Product Change Notification / JAON-19SJPJ307

CCB 4398.001 Final Notice: Qualification of MMT as an additional assembly site for selected Atmel ATSAML10D1xA, ATSAML11D1xA, ATSAMD11D14A, ATSAMD10D1xA, ATSAMD09D14A and ATMPS001D14A device families available in 24L VQFN (4x4x0.9mm) package.

Lead frame Comparison

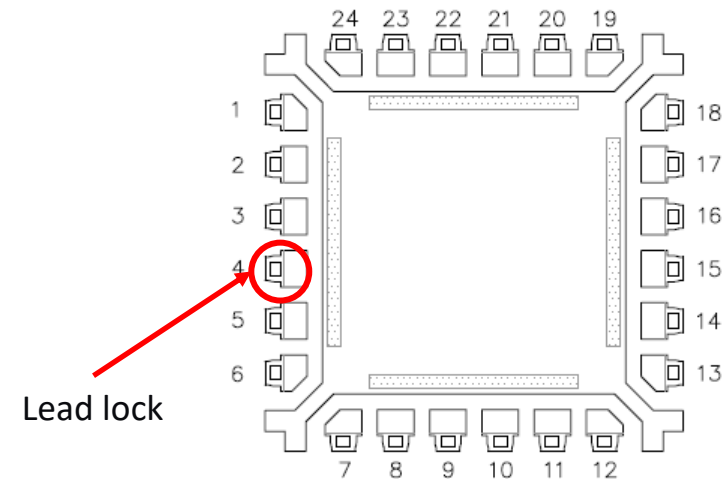
Pre Change ASE / ASCL

ASE	ASCL
LF Paddle Size	110x110	114x114
DAP Surface Prep	Ag Plated	Double Ag Ring Plated
Lead-Lock	No

Post Change MMT

LF Paddle Size	114x114
DAP Surface Prep	Ag selective plated
Lead-Lock	Yes

Note: The lead lock hole fills with mold compound during the assembly process and provides improved protection against moisture penetration around the interface edges between pins and mold compound.
